PROPOSED BAFFLES FOR PCAL AND PR /SR CAVITIES:

**-01 SHOWN
(Y-ARM)**

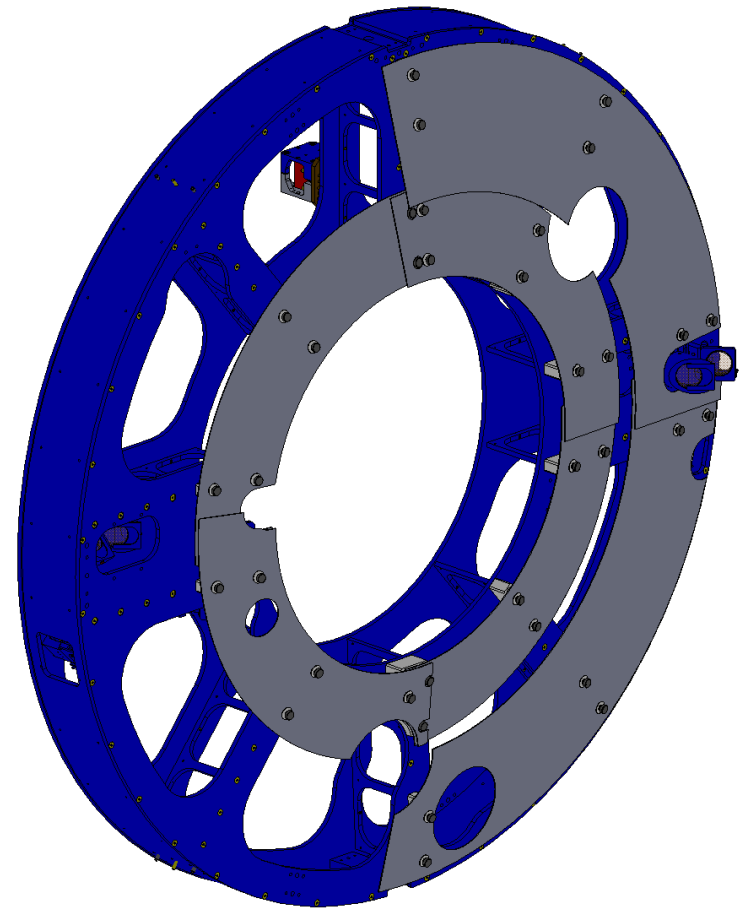
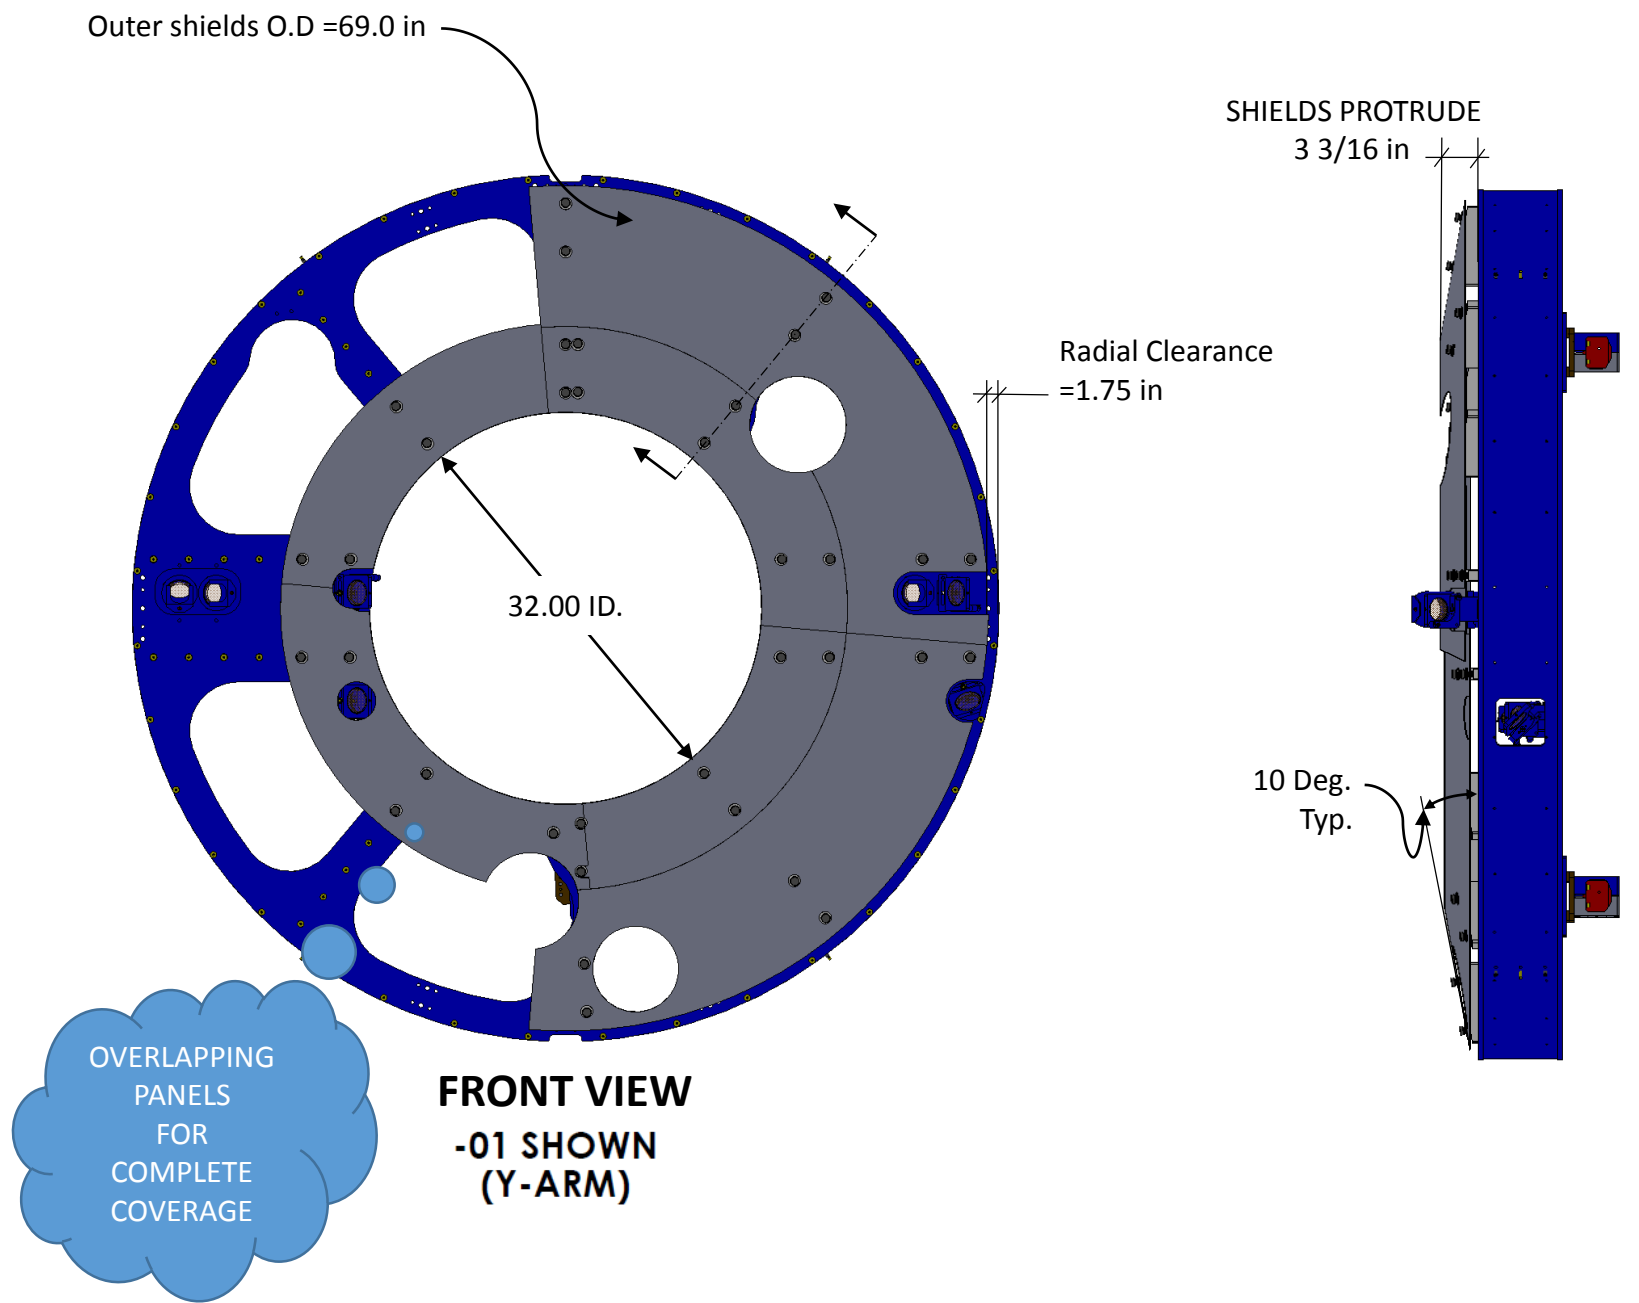
As built (Weight: 229.90 lbs)

REMOVED
PCAL MIRROR
MOUNTS
ASSY.
4 PL.

Modified with SLC Shields
(Weight: 245.00 lbs Approx.)

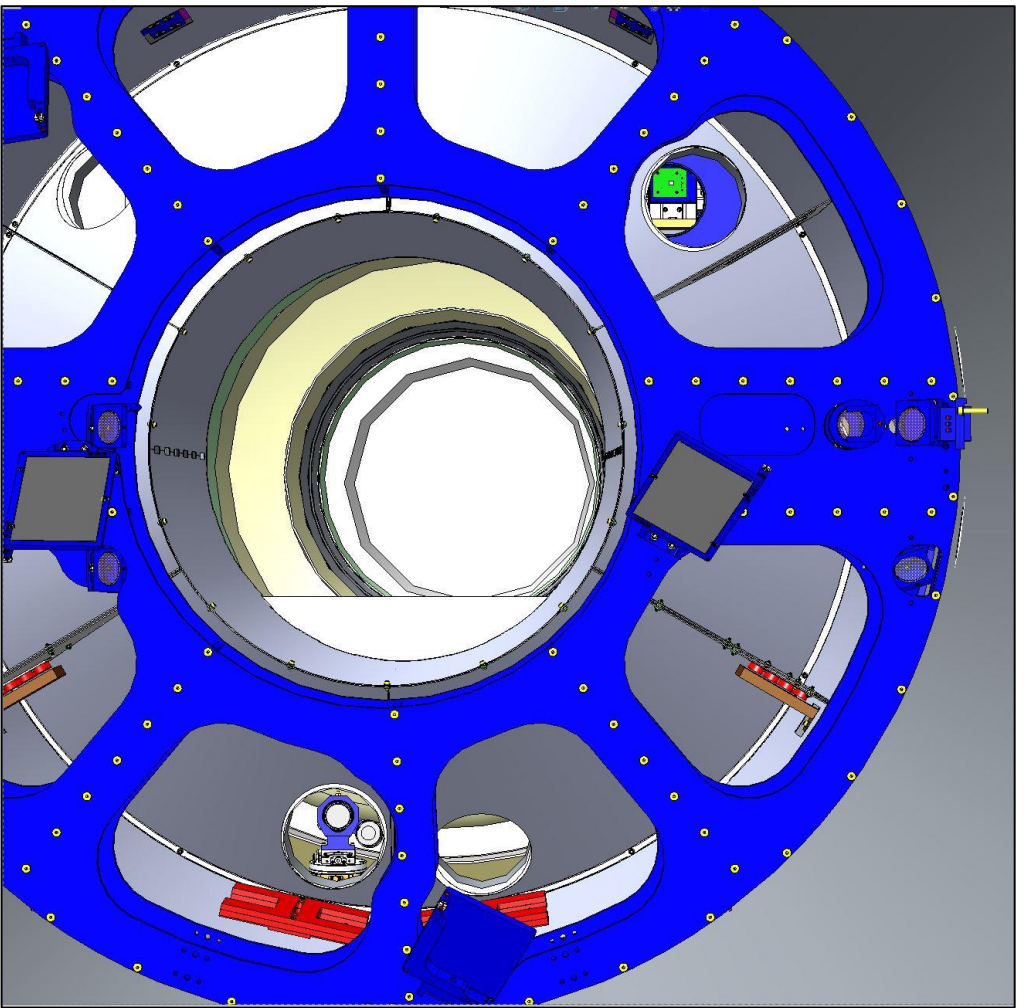
As built

With PCAL shields
